ISSUE: Certificate of Appropriateness for alterations and Waiver of Vision Clearance

APPLICANT: NOVA Petroleum Realty, LLC

LOCATION: Old and Historic Alexandria District
801 North Washington Street

ZONE: CDX/Commercial Downtown Zone (Old Town North)

Figure 1: LED price sign at 442 N Henry

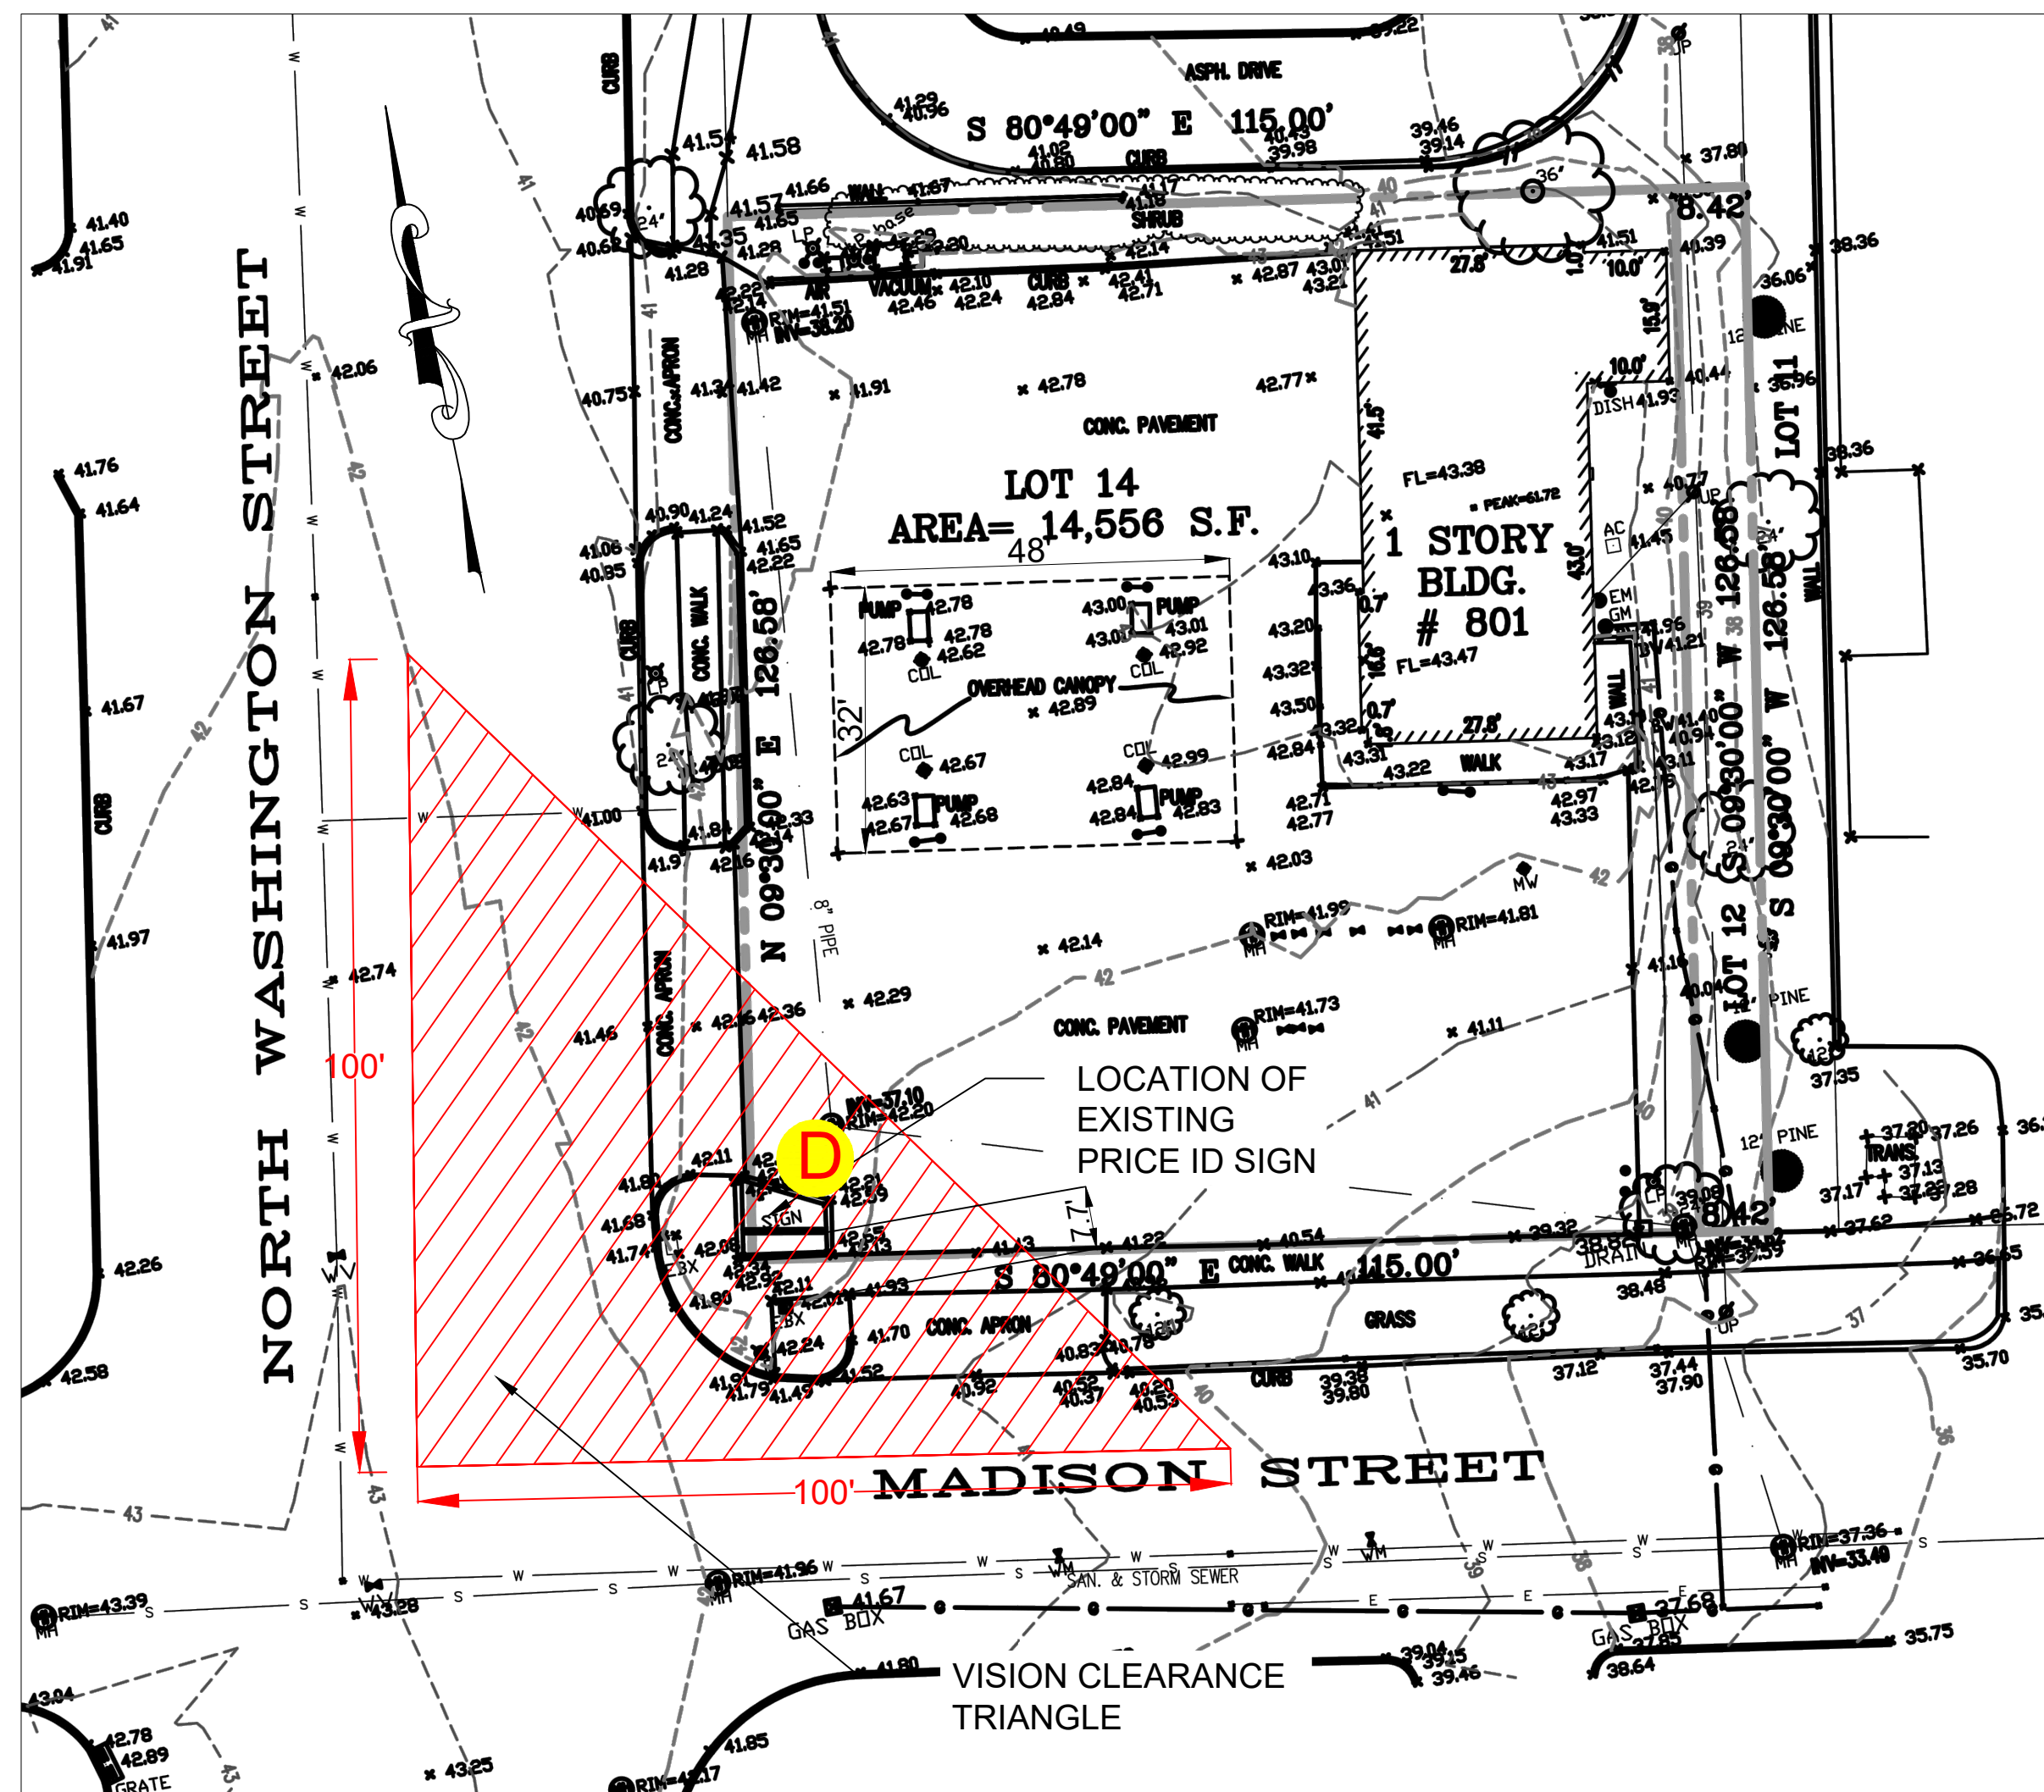
The price numbers are proposed to be LEDs, which is the now the industry standard, and these have been installed on stations throughout Alexandria, including the Shell station that was approved several years ago by the PG BAR for 442 North Henry (Figure 1). Staff has not received any objections from the community about these lights. However, the present applicant has agreed to install dimmers on the LEDs and to work with staff in the field at night to reduce their intensity if they are found to be incompatible with the illumination levels of the surrounding streetscape on Washington Street, as is the BAR's standard condition for lighting.

D PROPOSED PRICE ID SIGN

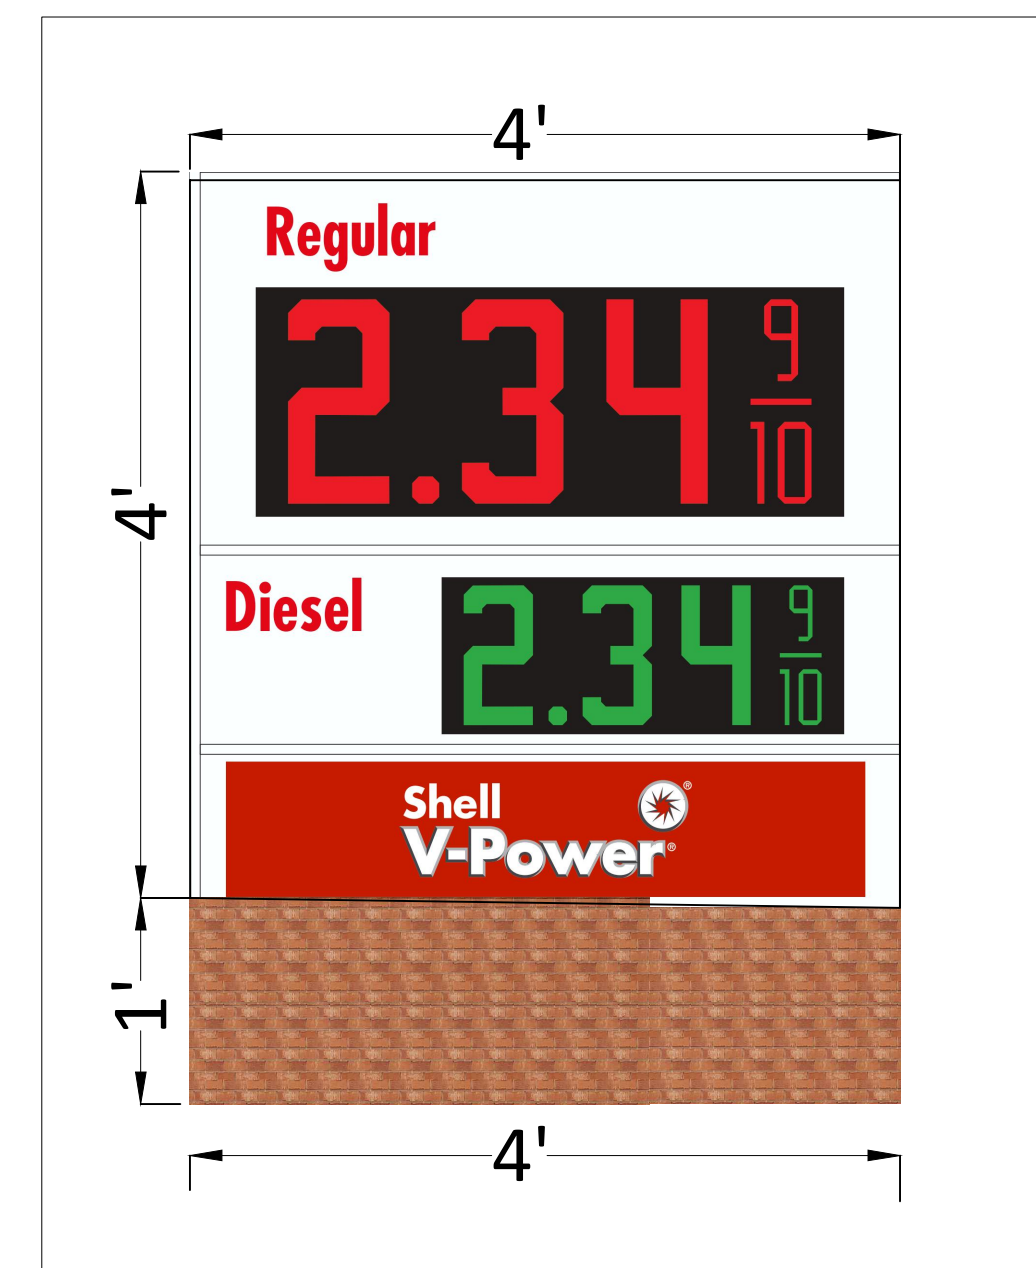
1. No signs on the site may be internally illuminated except for the price numerals on the monument sign, whose intensity is to be reviewed by staff at night in the field to ensure the compatibility of the illumination with the surrounding streetscape.

- The site is located within the North Washington Street area from Bashford Lane to Pendleton Street. The proposal is for new signage at an existing petroleum station.
- The proposed price ID sign as we appreciate the scale of the sign being reduced significantly and the use of a brick base to provide continuity within the historical character of the parkway the illumination of the sign is not appropriate and we would ask you to reconsider the illumination.

Therefore, staff recommends approval of the proposed sign plan, with only the price numerals themselves on the monument sign internally illuminated, and with the intensity of the sign lighting to be reviewed by staff at night in the field to ensure the compatibility of the illumination with the surrounding streetscape as is the BAR's standard condition.
